Service Bulletin

Bulletin No.: 16-NA-106

Subject: No Start, or Stall Condition, Erratic Shifting, A/C Inoperative

Brand:	Model:	Model Year:		VIN:		Engine:	Transmission:
		from	to	from	to		
Chevrolet	Cruze Limited (VIN P)	2016	2016			All	All

4481231

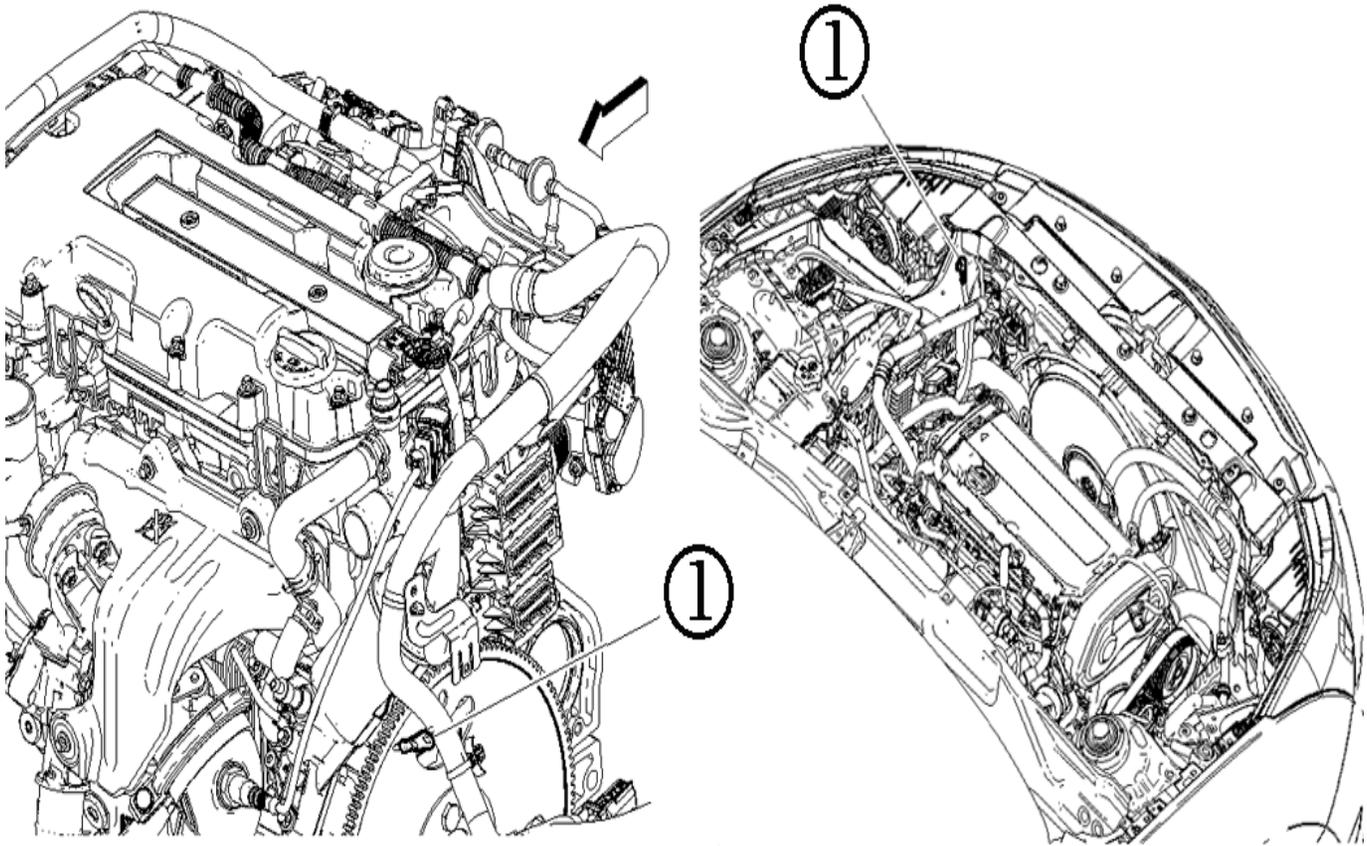
Inspect the G114 ground connections (1) and all other grounds on the engine. Check the engine compartment G114 ground connections (1), located on the left side, forward of the battery. Repair as needed.
